Drawing Change Notice

CHANGE DOCUMENT NO.
24590-PTF-VDCN-MS-10-00007

JOB NO.	TITLE FOR CHANGE NOTICE
24590	UFP-VSL-00062A Redesign

JUSTIFICATION FOR CHANGE	CAUSE CODE
Based on the re-analysis of UFP-VSL-00062A, per calculation 24590-PTF-MVC-UFP-00023, for revised seismic conditions and design evolution, required a redesign of the vessel.	01 and 23

36" CHARGE VESSEL & INNER PJM SUPPORT
SCALE: ½" = 1'-0"

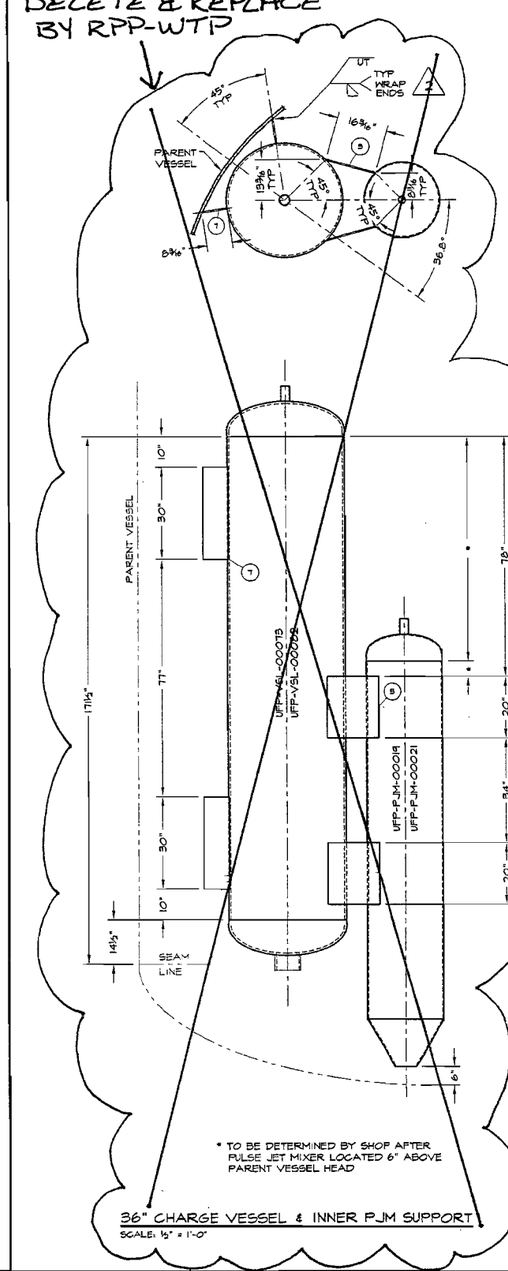
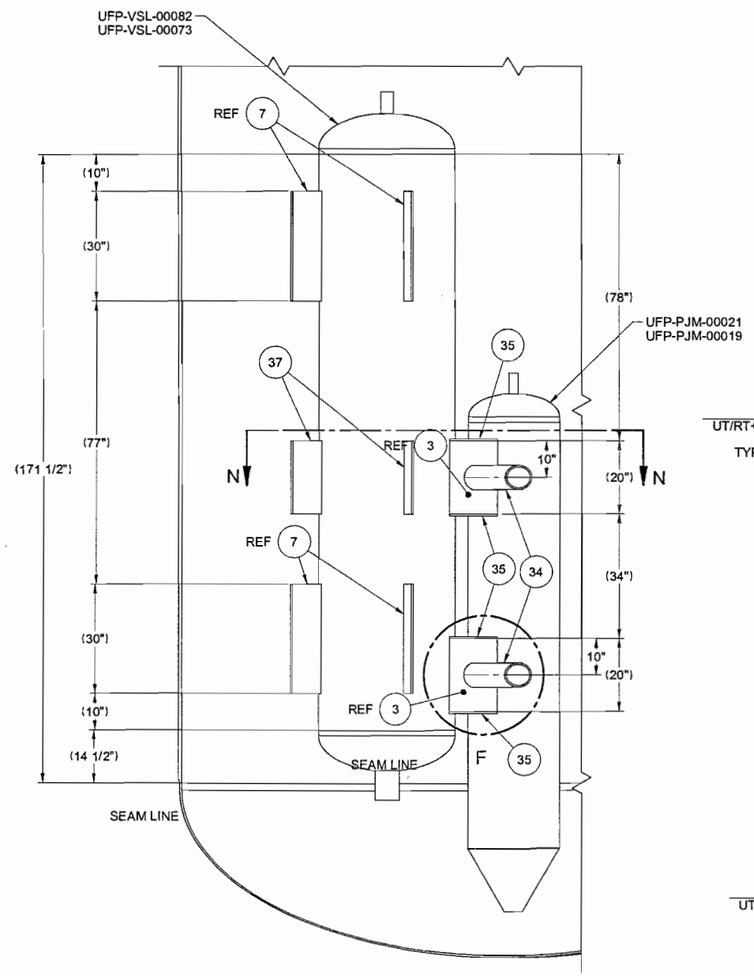
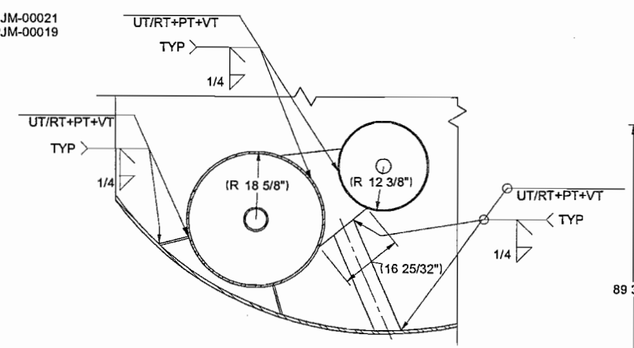
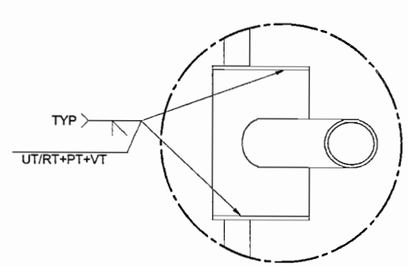
c.) 36" Charge Vessel & Inner PJM Support: Delete 36" Charge Vessel & Inner PJM Support and replace with 36" CHARGE VESSEL & INNER PJM SUPPORT, SECTION N-N, item 35 DETAIL F, and associated views shown on Attachment 1, page 14 of this VDCN.

DELETE & REPLACE BY RPP-WTP

180" I.D. ULTRAFILTER PERMEATE COLLECTION VESSEL DETAILS

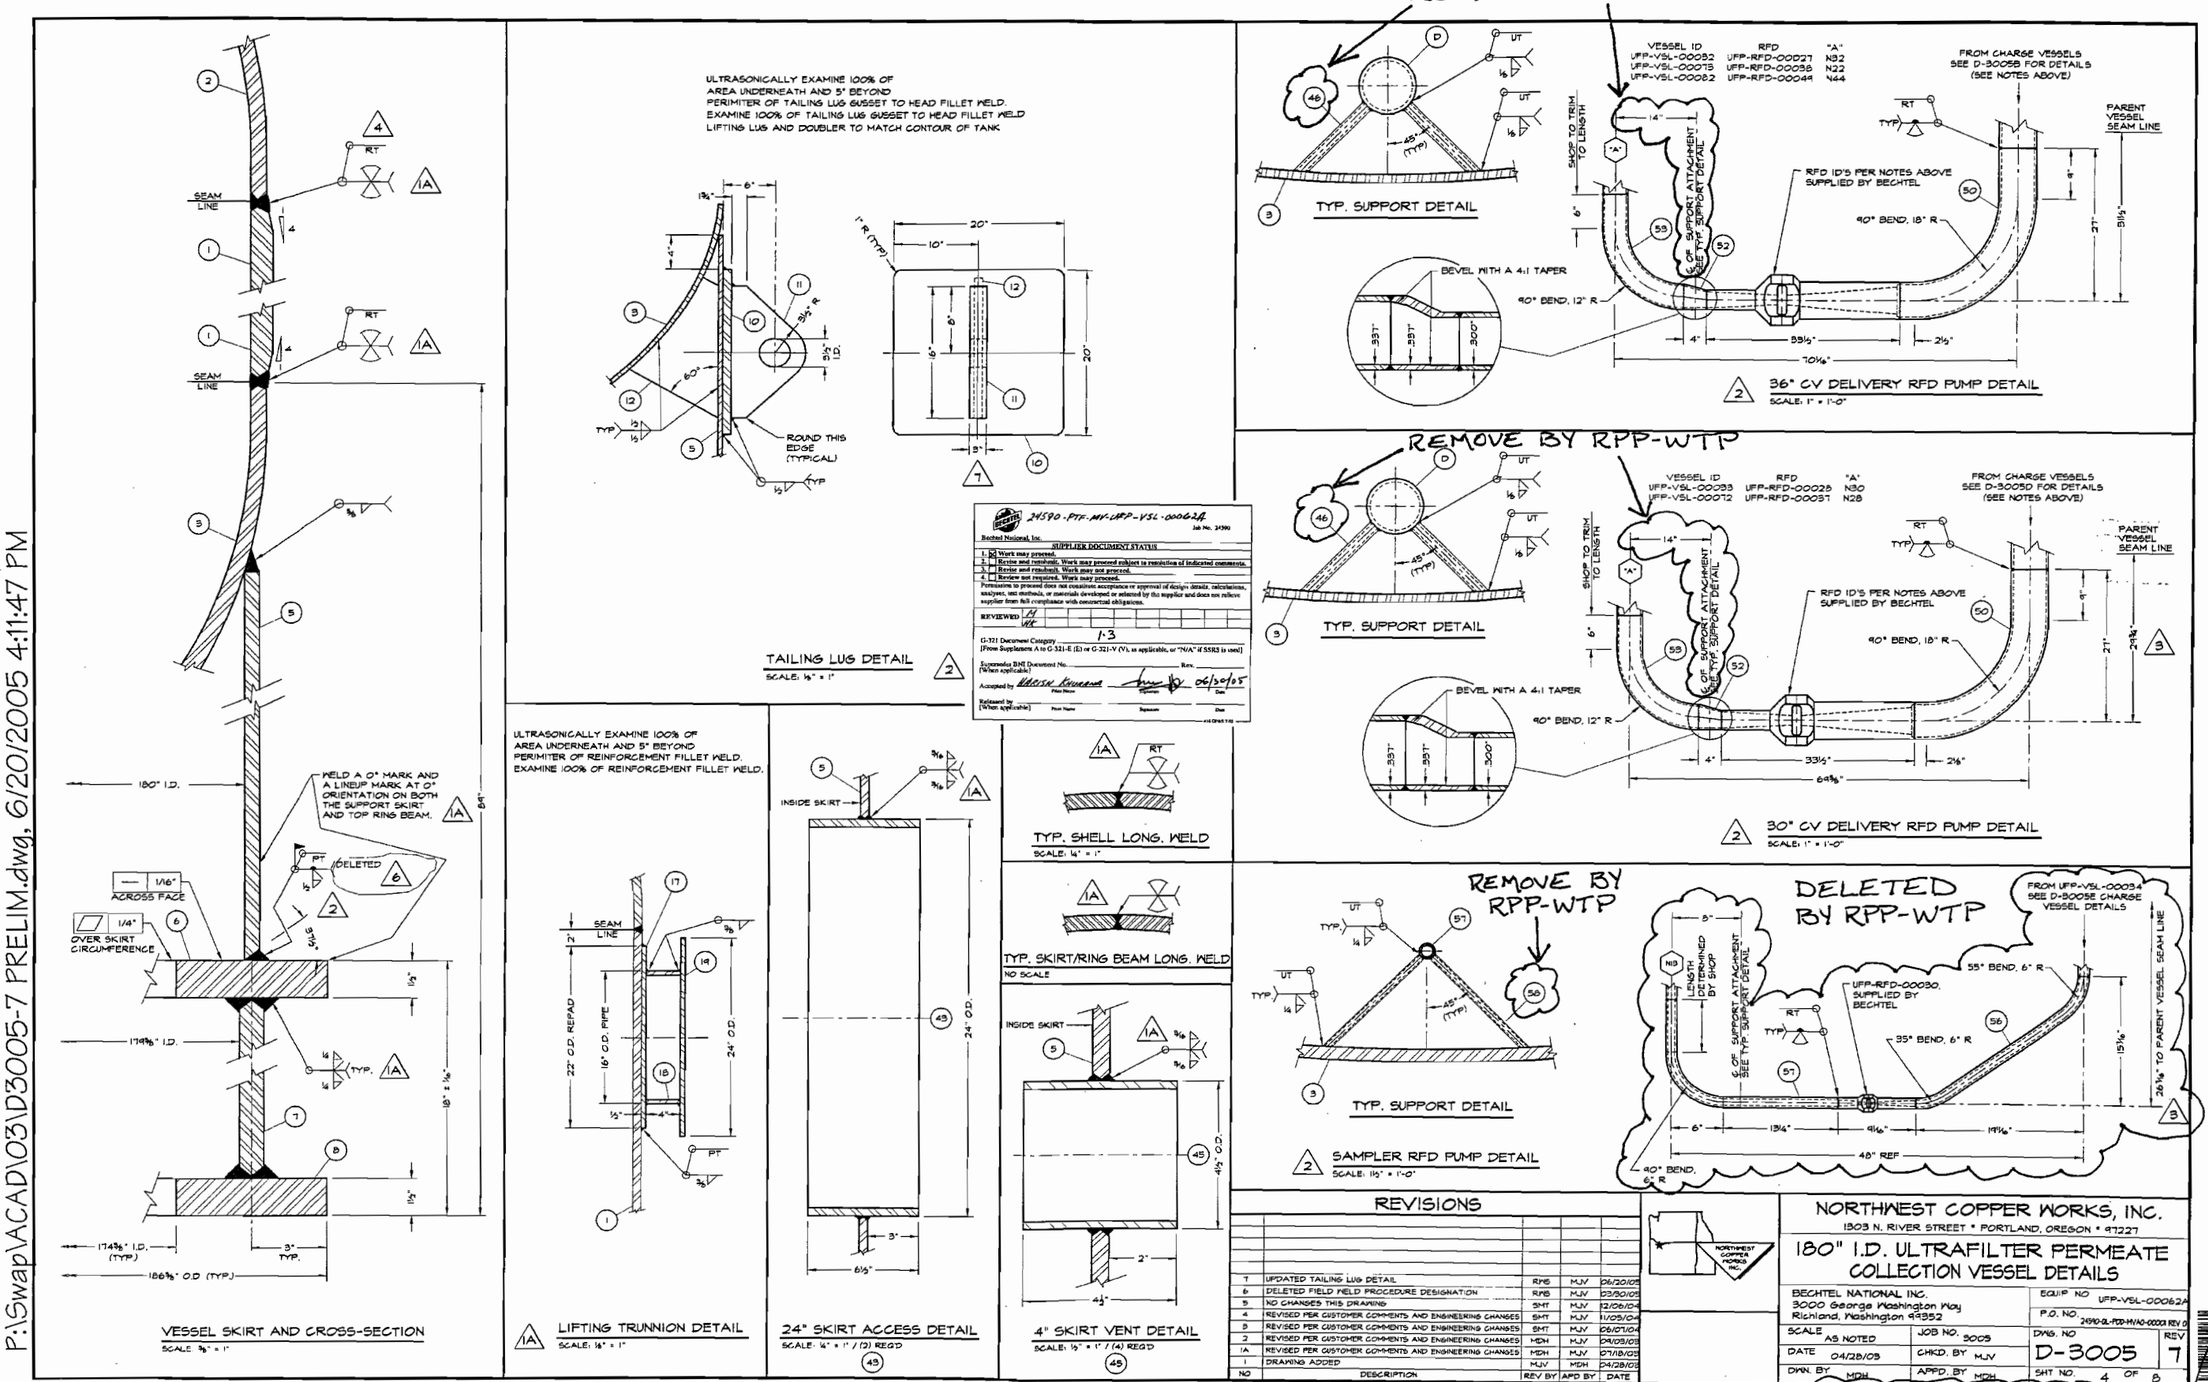
a.) 36" CV Delivery RFD Pump Detail: Remove support item 46 from TYP SUPPORT DETAIL and reference to SEE TYP SUPPORT DETAIL including dimension.

b.) 30" CV Delivery RFD Pump Detail: Remove support item 46 from TYP SUPPORT DETAIL and reference to SEE TYP SUPPORT DETAIL including dimension.

(1.) Remove support item 58 from TYP SUPPORT DETAIL.

SAMPLER PUMP RFD ASSEMBLY
SCALE: 1/20
SEE DWG 24590-QL-POD-MVA0-00001-03-01
FOR REFERENCE BOM ITEMS

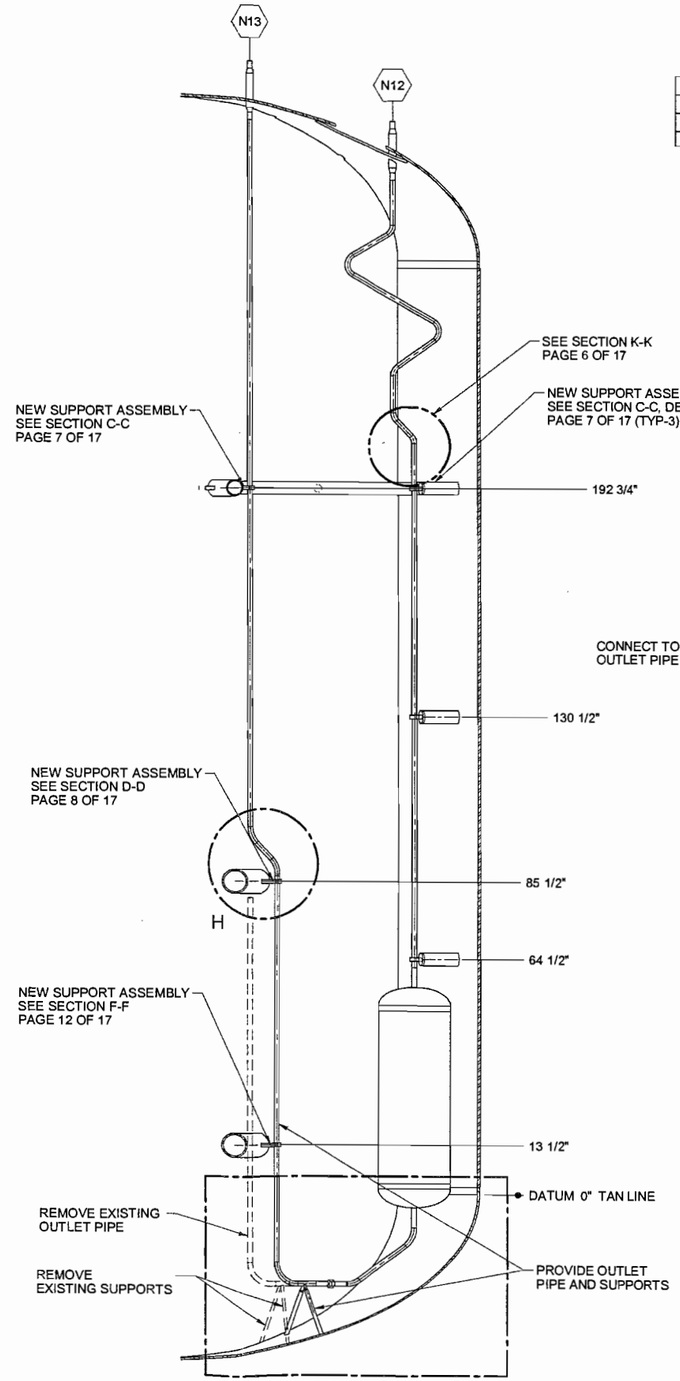
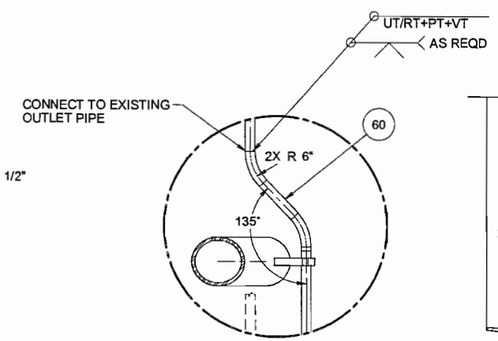
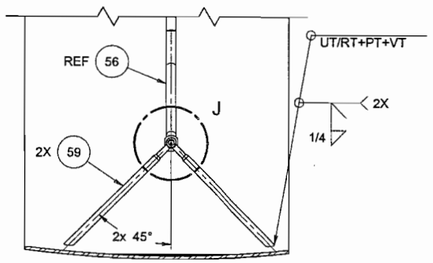
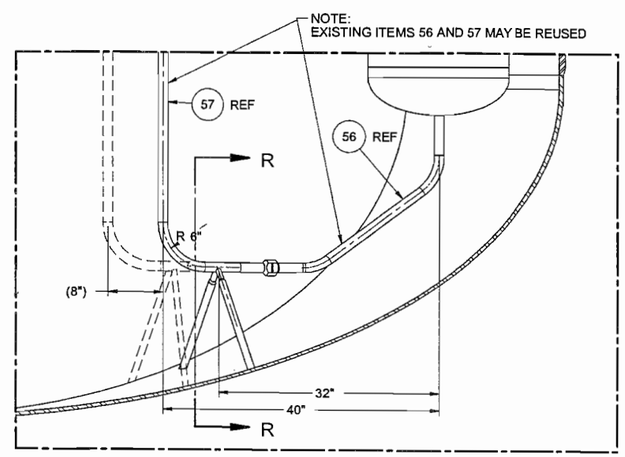
(2.) Add DETAIL J, SECTION R-R, and SAMPLER PUMP RFD DETAIL shown on Attachment 1, page 16 of this VDCN.

(3.) Delete Sampler detail and replace with SAMPLER PUMP RFD ASSEMBLY and DETAIL H shown on Attachment 1, page 16 of this VDCN.

2" SCH ~~80~~ 160 CAPPED NOZZLE W/ INT. PROJECTION
SCALE: 3/4" = 1"
N38 2

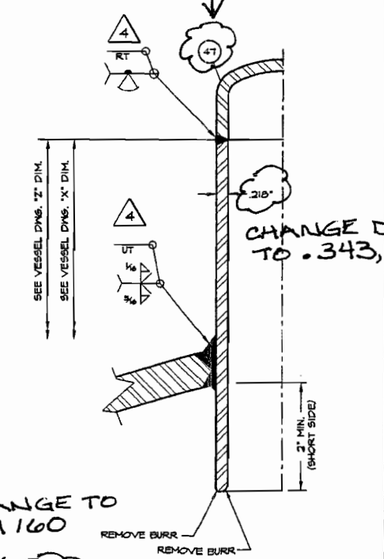
a.) 2" SCH 80 CAPPED NOZZLE W/ INT. PROJECTION (detail for N38): Remove item 47 and replace with 2" SCH 160 CAPPED NOZZLE.

b.) 2" SCH 80 CAPPED NOZZLE W/ INT. PROJECTION (detail for N38), change to read as follows: 2" SCH 160 CAPPED NOZZLE W/ INT. PROJECTION.

c.) 2" SCH 80 CAPPED NOZZLE W/ INT. PROJECTION (detail for N38): Change dimension of .218" to read .343".

REMOVE AND REPLACE WITH 2" SCH 160, BY RPP-WTP

CHANGE DIMENSION TO .343, BY RPP-WTP

CHANGE TO SCH 160

4" SCH 80 OUTLET FROM INTERNALS
SCALE: 3/4" = 1"
N28 N29 N30 N32 N44

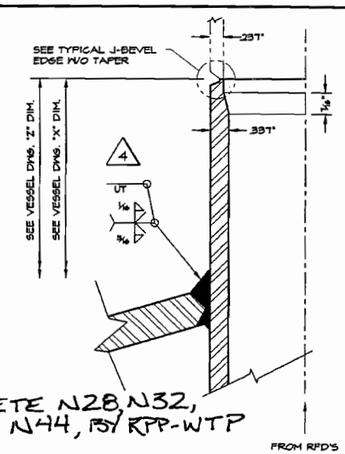
d.) 4" SCH 80 OUTLET FROM INTERNALS (detail for N28, N29, N30, N32, N44): Delete N28, N32, and N44.

DELETE N28, N32, AND N44, BY RPP-WTP
